From:	Selim <Selim@sawayaeng.com>
Sent time:	01/17/2019 07:53:59 AM
To:	So Kim
Cc:	Jill Martin <jmartin@trumpnational.com>; Ara Mihranian
Subject:	RE: Tract 50666 Fencing plan
Attachments:	2018-10-02 Fence-S1 snt2City+Coastal.pdf

TRUMP NATIONAL GOLF CLUB

FENCING / WALL PLAN

TRACT 50666

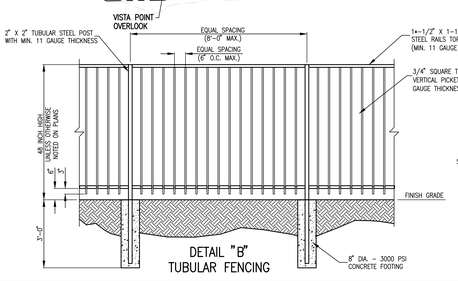
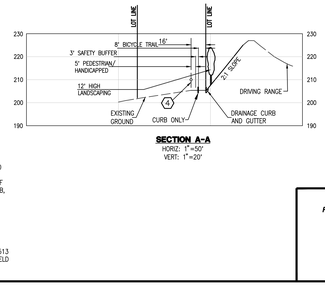
Note 1 - Need 42" rail fence on west side of trail. Need shorter fence on both sides of the 3' buffer.

Note 2 - This needs to be moved so that it's along the trail. Provide fencing on both sides of the West Portal Trail.
The fence can not be moved because it interfer with a sewer easement and the access to the sanitation district trunk line (see attached)

Note 3 - Need short fence along both sides of the 3' buffer.
Please see my response to note 1 above – This is an overkill

Note 4 - Need 42" south side of trail AND shorter fence on both sides of the 3' buffer
A rail in the area you are requesting does not have neither a safety purpose nor to protect habitat. A rail in this area should not be required. As for a short fence on both sides of the 3 ft buffer, please see my response to note 1 above.

Note 5- Need 42" fence along east side of trail. (west bluff trail)
The trail is constructed and open to the public. A stone wall and vegetation seperate the golf course from the traill – A fence in this location is not required.

- This is very tricky because of sewer and storm drain easements that should not be fenced. See attached exhibit
- A shorter fence on both side of the 3 ft buffer is overkill and will not be provided. We are not conditioned for it, It is a tripping hazard, it will take away from the natural look of the area that everyone wants to preserve, It is not provided anywhere within the property.
- A 6" AC curb will be provided between the bike path and the 3' buffer only as Coastal recommended.
- The 3' buffer will be vegetated.
